From:	Randall Fedors
Sent:	Monday, June 19, 2006 3:10 PM
To:	Brittain Hill
Cc:	Alexander Sun; Budhi Sagar; Robert Latta; Andy Campbell; Allen Fetter; Jack Guttmann; Jin-Ping Gwo; Elmo Collins; Lawrence Kokajko; Philip Justus; Timothy McCartin; Wilkins Smith; Eugene Peters; Jack Parrott; James Rubenstone
Subject:	Re: Report of Unexpected Geologic Condition
Attachments:	szfaults.JPG

Some relevant comments on faults in the DOE SZ flow model.

Figure 4. Features of the Base-Case Saturated-Zone Model with East-West Barrier Included

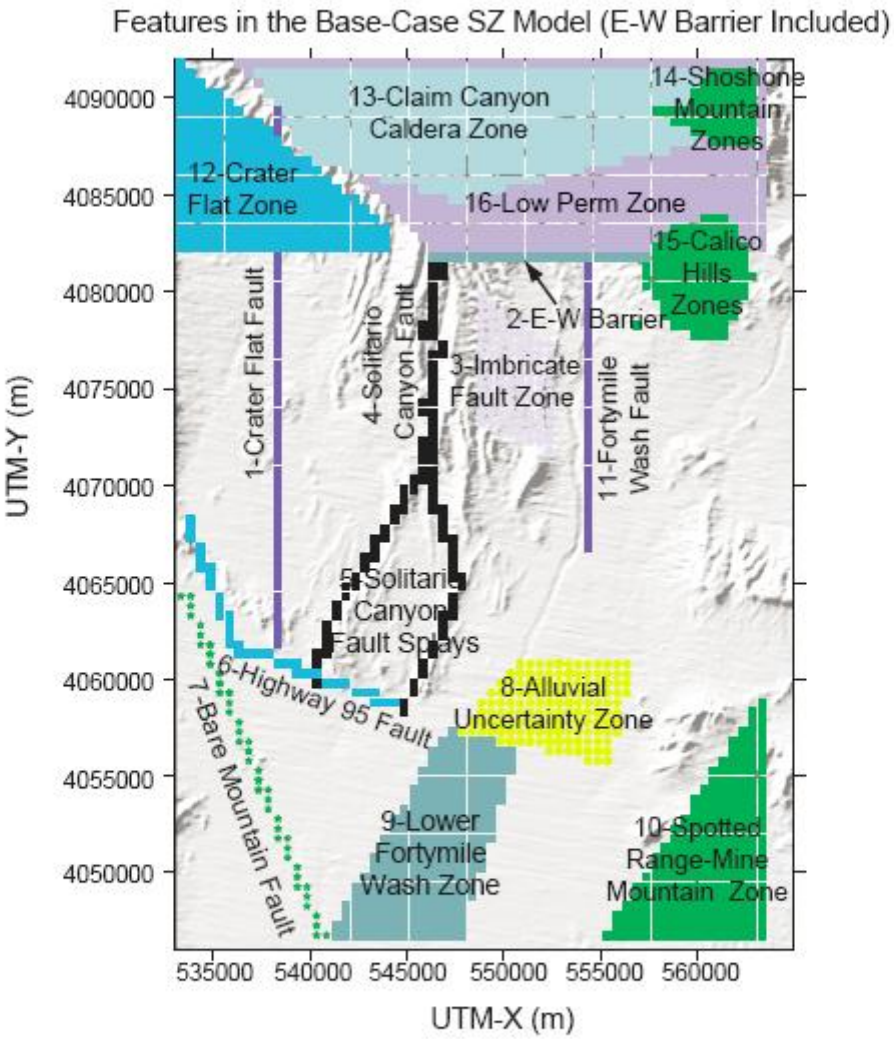
There are only a few faults in the DOE flow models are explicitly modeled as flow features (i.e., a Solitario Canyon Fault and it's splay, a Fortymile Wash Fault, a Bare Mountain Fault, and a Highway-95 Fault). The attached figure (sent by Alex Sun at the center) of the DOE SZ model that shows the faults that are explicitly included in their model. Note that the attached figure is markedly different in scale form Britt's aeromagnetic plot. The eastern splay of the Solitario Canyon Fault in the DOE SZ model corresponds to the general area near Well 24P. Obviously, the representation of faults in the DOE SZ model is extremely simplified. Because of the coarseness of the DOE SZ model, placement of the fault would not matter much (+/- 500 meters is not important). Thus, it only matters that the data from Well 24P be applied to the fault properties (not to interblock properties); i.e., do not upscale the flow rate to interblock properties, just apply it to fault properties. The implied conclusion is that the flow rate seems less extreme. However, we haven't identified the range of fault flow properties with which to compare Well 24P results.

Note that the DOE grid is coarser than 10 m vertically-speaking. The model has vertical spacings increasing with depth, but is everywhere greater than 10 m. Thus the 10-m interval from the borehole is at a much smaller scale than the DOE SZ model grid; i.e., we have a scaling analysis to perform here (along the lines of a small zone of high flow, upscaled with larger zones of lower flow).

To sum this up, I don't think this is leading up to an unexpected condition, though we do need to keep following up and firming up our "facts." Of course, this doesn't address the issue of adequate representation of faults in the flow models.
